MISSISSIPPI POWER & LIGHT COMPANY

SUBJECT: Grand Gulf Nuclear Station
Units 1 and 2
Docket Nos. 50-416 and 50-417
File 0260/0862
Transmittal of Proposed FSAR
Changes and Responses to NRC
Questions
AECM-81/277

This information represents changes to the Grand Gulf Nuclear Station Final Safety Analysis Report (FSAR).

MISSISSIPPI POWER & LIGHT COMPANY GRAND GULF NUCLEAR STATION UNITS 1 & 2 FINAL SAFETY ANALYSIS REPORT	SETTLEMENT VS TIME UNIT 1 TURBINE BUILDING FIGURE 2.5-75b Sheet 1
--	--

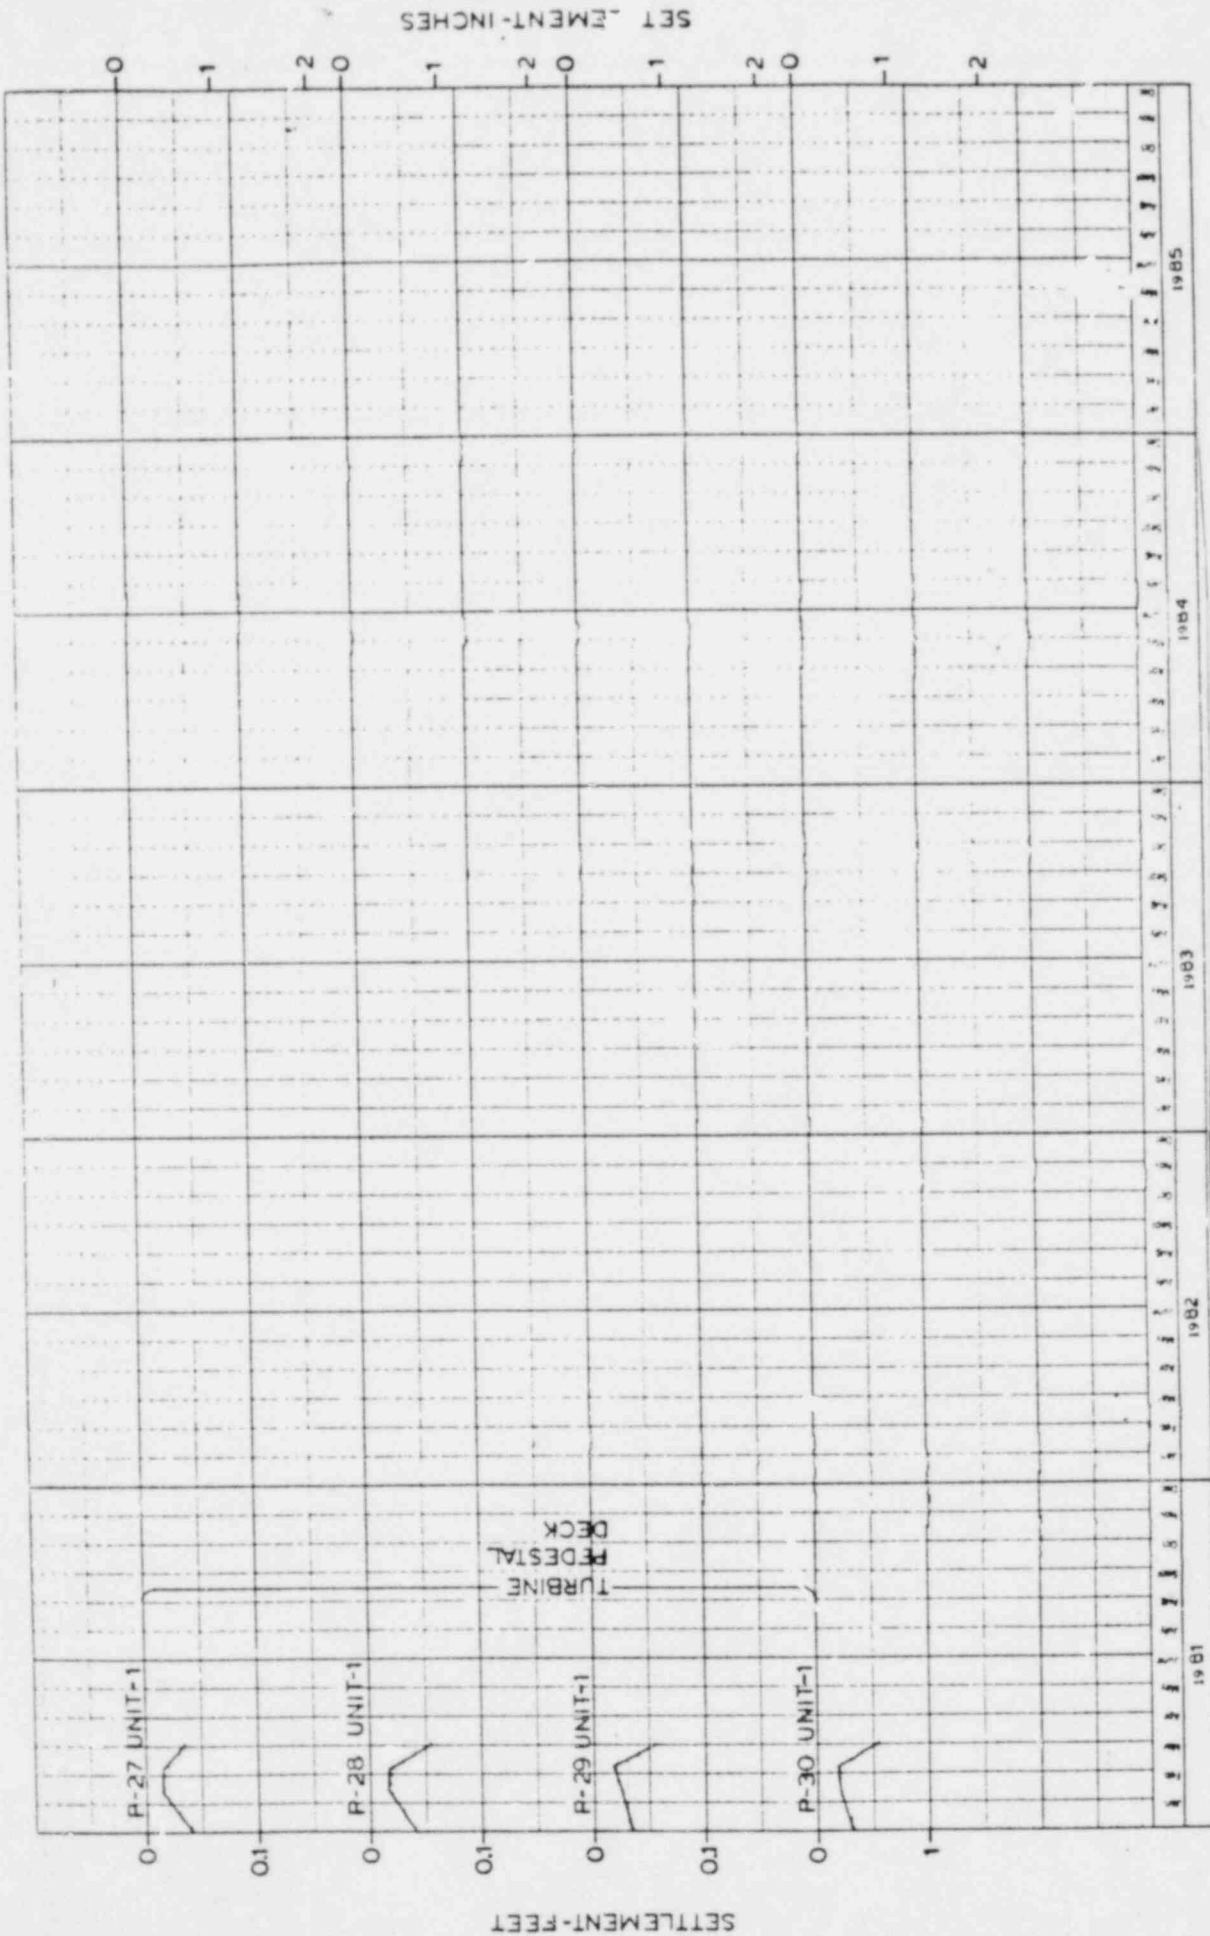
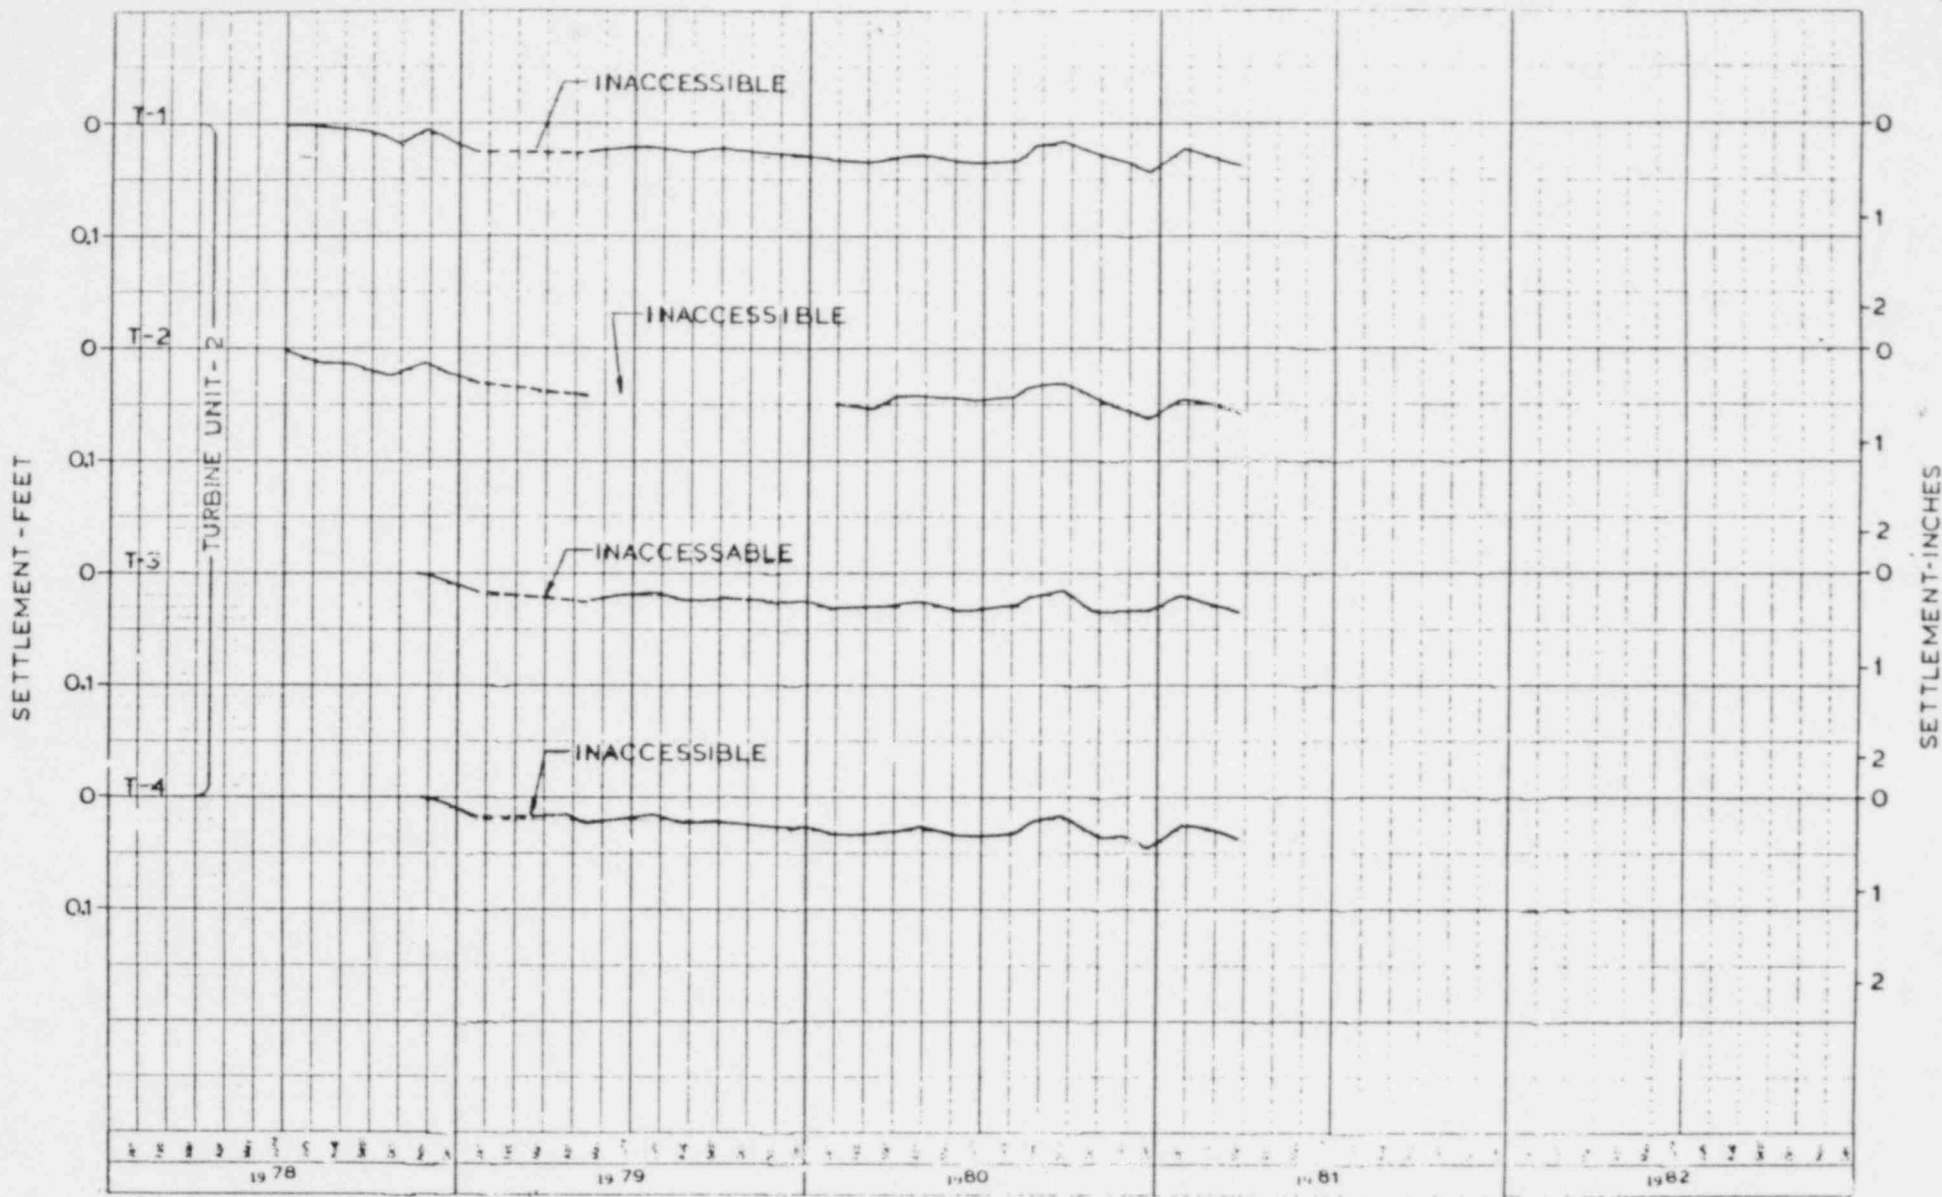
362.7
(2.5.4.13.1) Your response to NRC Question 362.5 (page Q&R 2.5-14, Amendment 30) is not complete. Indicate what measured value of differential settlement would cause code allowable stresses to be exceeded for individual buildings and buried piping and require notification of NRC. Provide a table of these values and the limiting stress criteria. Update the plots which show settlement recorded to date versus time; this is particularly important since construction of Unit 2 was still underway when your response to Question 362.5 was being developed.

The response to this question is given in revised subsection 2.5.4.13.1, revised Table 2.5-10 and revised Figures 2.5-75a through 2.5-75h.

The settlement markers will be read at one-month intervals until construction is complete and all pools are filled with water, at which time the results of the settlement monitoring program will be evaluated and long-term monitoring of the structures will be assessed. Total settlement will not be a Geotechnical concern until the following measured values are observed:

Turbine building	3"
Radwaste building	3"
Control building	3"
Containment building	3.5"
Auxiliary building	3.5"
Diesel generator building	3"
